Title: **STAGE 1 QUALITY AUDIT**

Sandyford Central.

Report reference: **0653R01**

This report was prepared in response to a request from Mr. Patrick Raggett, OCSC on behalf of Sandyford GP Limited (Acting in its capacity as general partner for Sandyford Central Partnership) for a Stage 1 Quality Audit of the proposed residential development at the former Aldi site, Commonhall Road, Sandyford Business District, Sandyford, Dublin 18.

Drawing SFC-OCSC-00-00-DR-C-0001 A1, C01

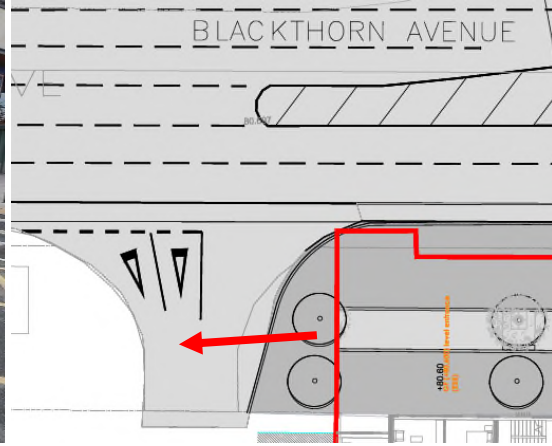
There are inadequate crossing facilities for pedestrians wishing to cross the car park to the West of the proposed development on Blackthorn Avenue. Without suitable tactile paving, partially sighted pedestrians may inadvertently enter the carriageway resulting in a greater risk of a collision with vehicular traffic.

The existing crossing has black (pavement) and white strips that may make it look like a zebra crossing however it is an uncontrolled crossing. This may lead to pedestrians thinking that they have right of way over vehicular traffic and may enter the crossing without due caution.

There are existing tactile paving slabs and dropped kerbs at the Blackthorn Avenue edge of the existing footpath. This may lead pedestrians to cross here where it is not as safe as crossing at a greater setback given the width of the car park access.

It is recommended that the crossing is upgraded to a zebra crossing or that the white strips are removed.

It is further recommended that the appropriate tactile paving is provided.

Lastly, it is recommended that the existing tactile paving at the carriageway edge be removed and a full height kerb be provided to deter pedestrians from crossing at that location.

Drawing SFC-OCSC-00-00-DR-C-0002 A1, C01

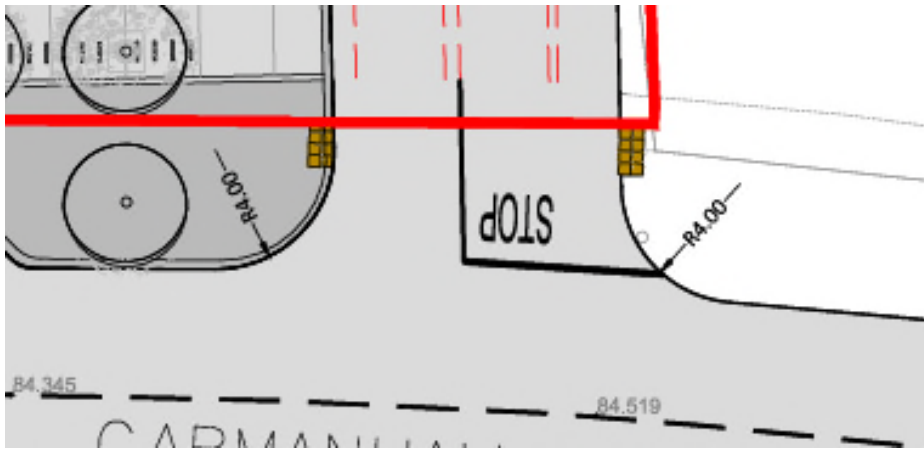
The drawing shows tactile paving at the crossing of the access to the basement on Carmanhall Road. This is an in-line crossing and there is a risk that blind or partially sighted pedestrians may step over the tactile paving and inadvertently enter the carriageway where they would be at greater risk of being struck by a vehicle.

It is recommended that the tactile paving for in-line crossings be at least 1.2m deep.

Problem 3.2

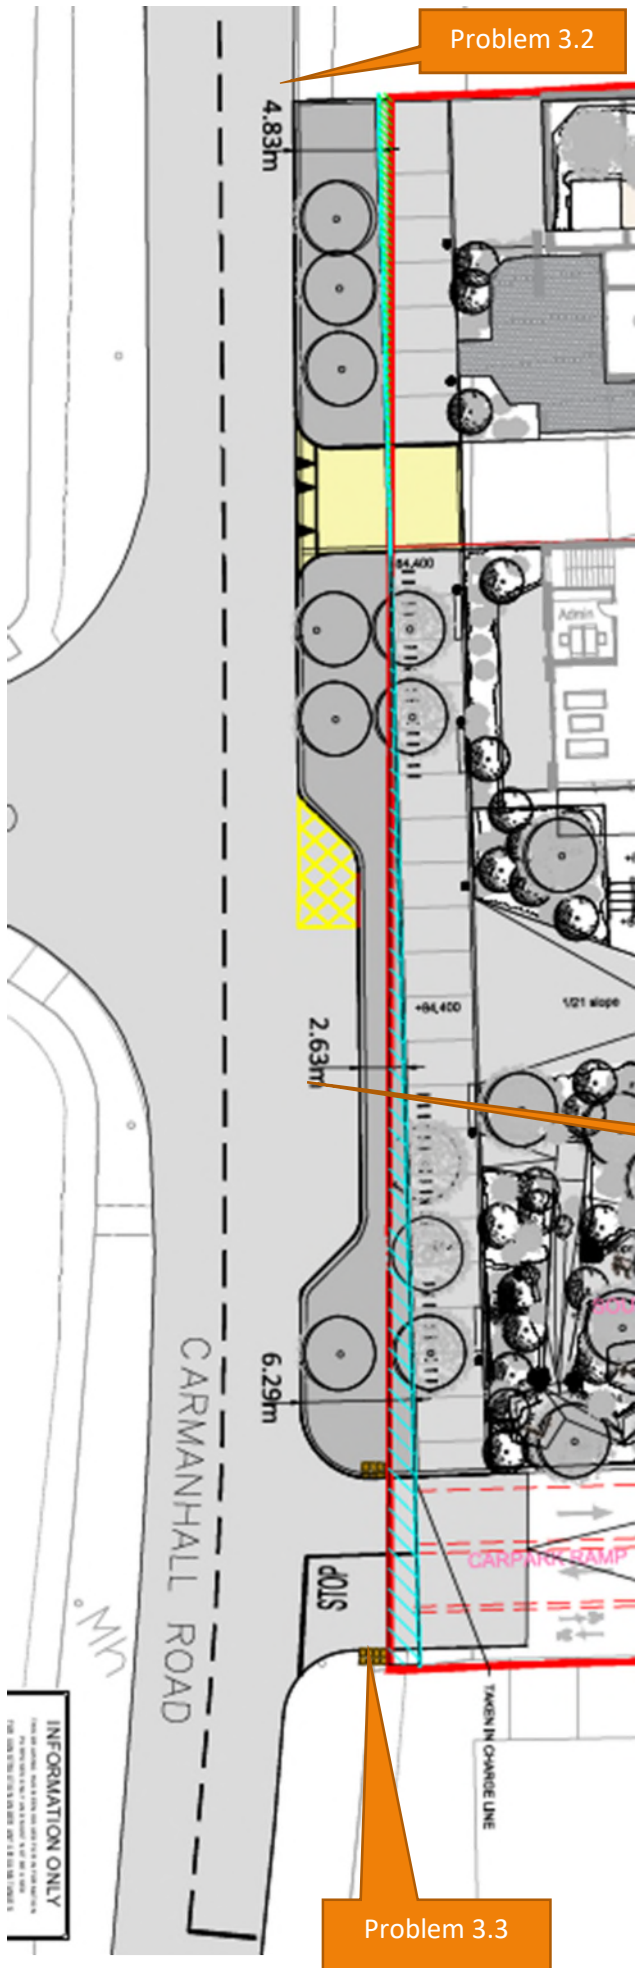
There is an existing advisory cycle lane on northern side of Carmanhall Road to the West of the proposed development. There are no facilities for cyclists along the site boundary. The lack of cycle facilities will lead to drivers being less aware of the presence of cyclists and a greater risk of collisions between the road user groups.

It is recommended the cycle lane be continued along the front of the development to the existing signalised toucan crossing East of the proposed site.

Problem 3.4

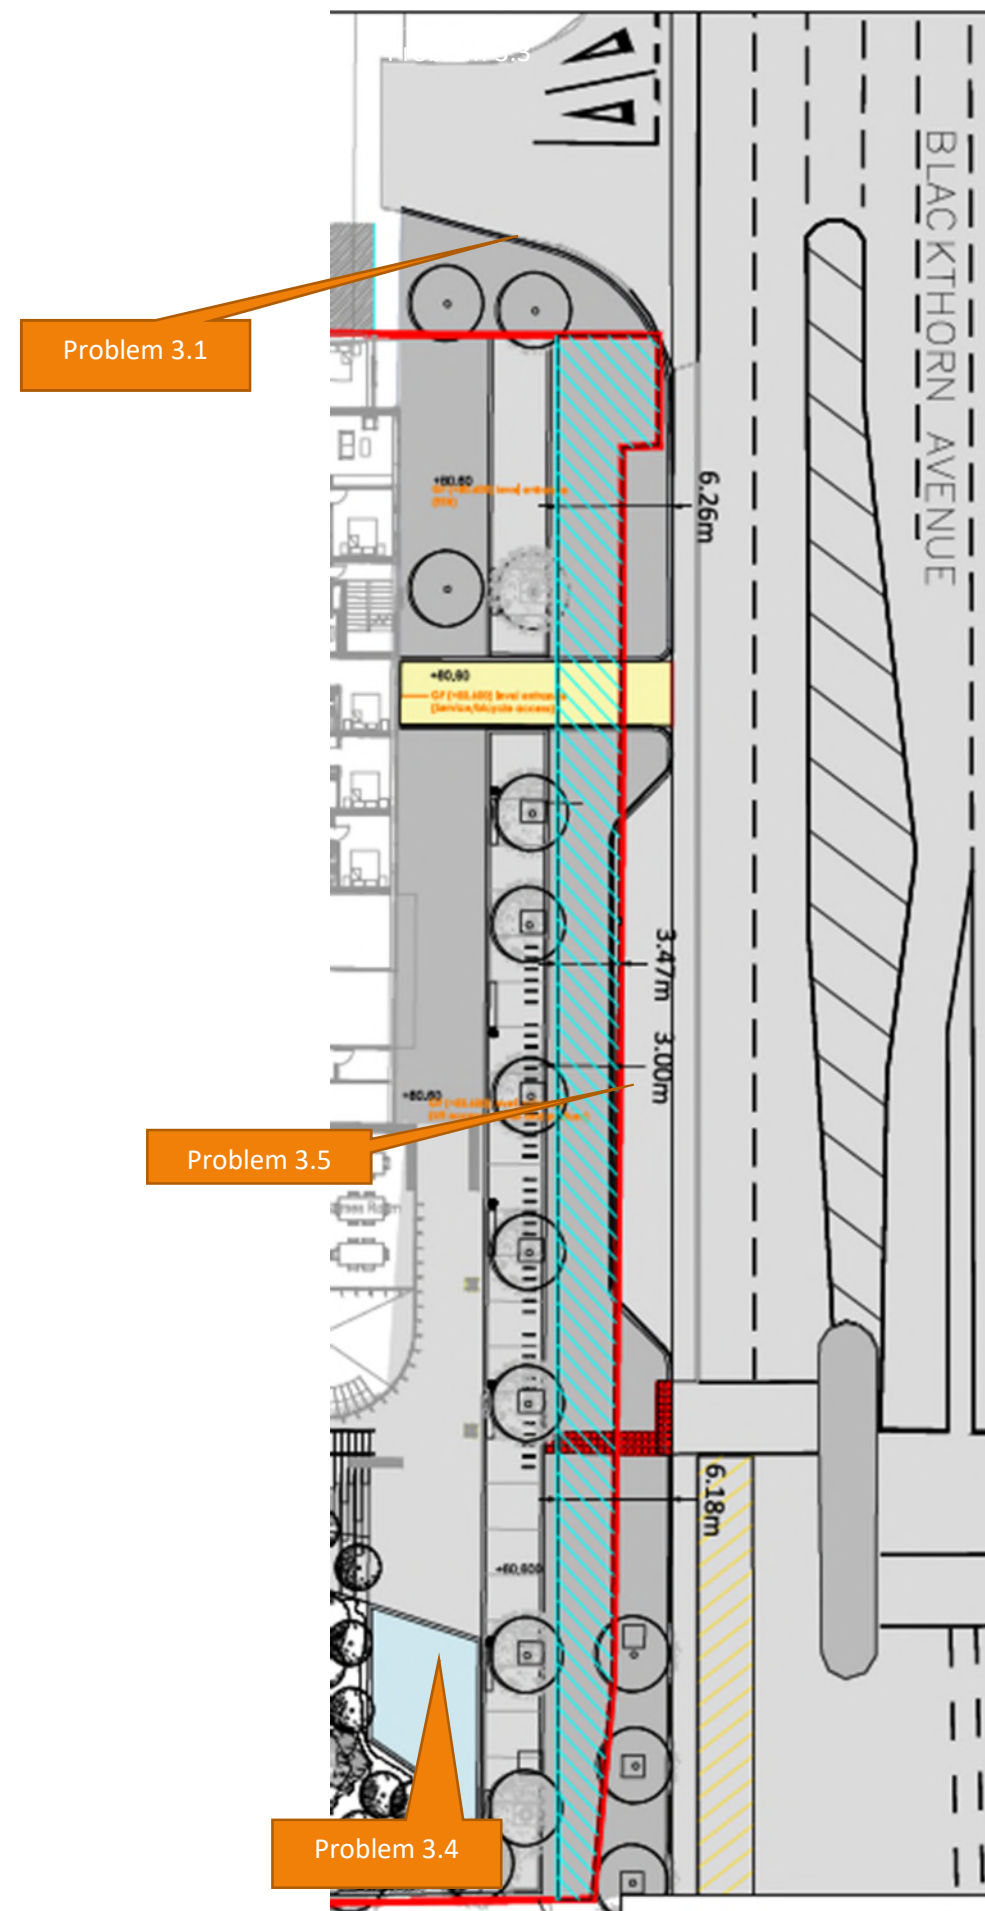
There are a number of disabled parking bays that have structural columns located within the space required for disabled drivers to enter/exit their vehicles. This could lead to disabled drivers being trapped and unable to get to their destination.

It is recommended that the columns be relocated.
